MILITARY SPECIFICATION

HEADSET-MICROPHONE, LIGHTWEIGHT, SUPRA-AURAL,
GENERAL SPECIFICATION FOR

This amendment forms a part of MIL-H-83535, dated 1 September 1989, and is approved for use by the Department of Air Force and is available for use by all Departments and Agencies of the Department of Defense.

NOTE: The response curve is typical and may 'float' within the envelope.
FIGURE 14. Transmit response envelope. "

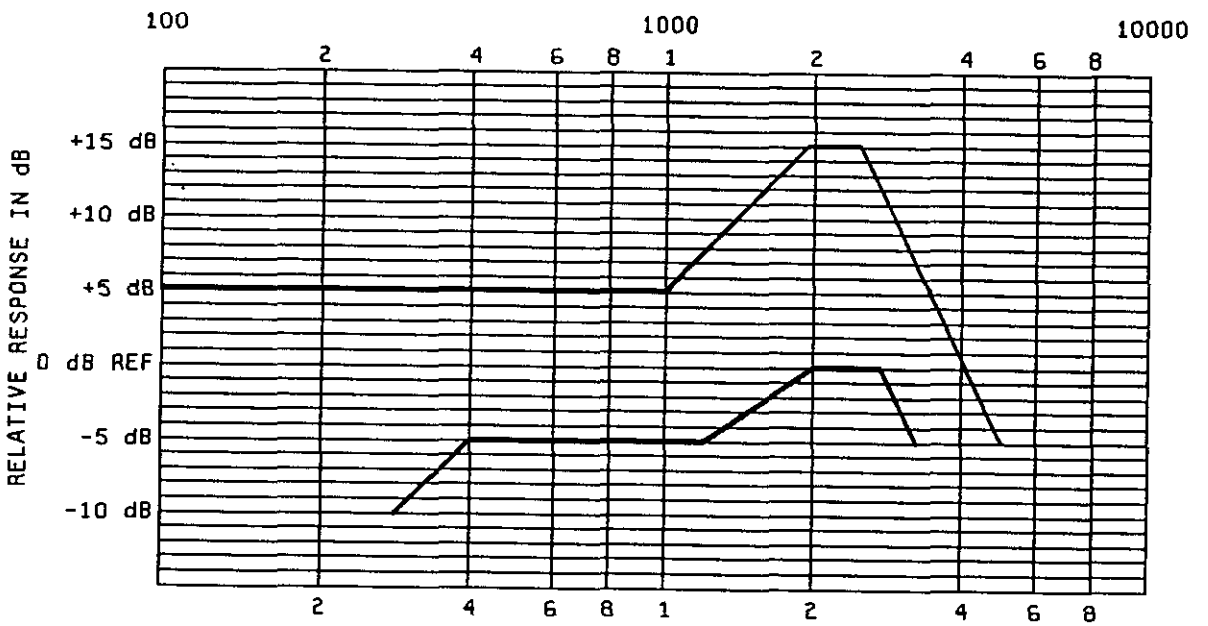
FIGURE 14, delete and substitute.

FIGURE 22. Input impedance test circuitry."

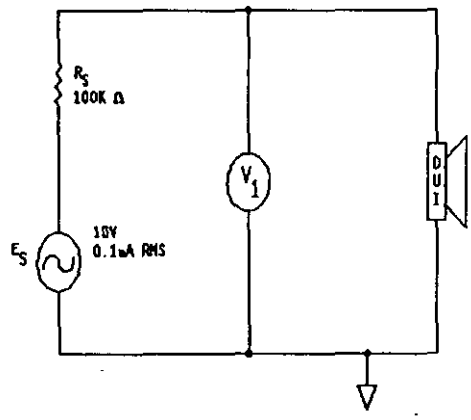
4.7.21, delete and substitute:

"4.7.21 Input impedance. Receiver impedance shall be determined to be the average of measurements taken at 500 Hz, 1,000 Hz, and 2,000 Hz. Each measurement shall be taken using the constant current method described in figure 21."

$$I = \frac{10V}{100K\Omega} = 100uA$$

$$Z = \frac{V_1}{100uA} = 10^4\ V_1$$

1. Constant current generator may be made with oscillator in series with 100 ohm resistor. Other values of E_s may be used (3.0 V_{RMS} min.). Then

$$Z = \frac{V_1}{E_S} \times 100K\Omega$$

2. Do not use ammeter to set current. Use floating voltmeter (true RMS) across R_S to avoid ground loops
3. Example calculation: V_1 is 30mV for 300 ohms Z and V_1 is 600 ohms Z.
4. All tolerances are ±1%.
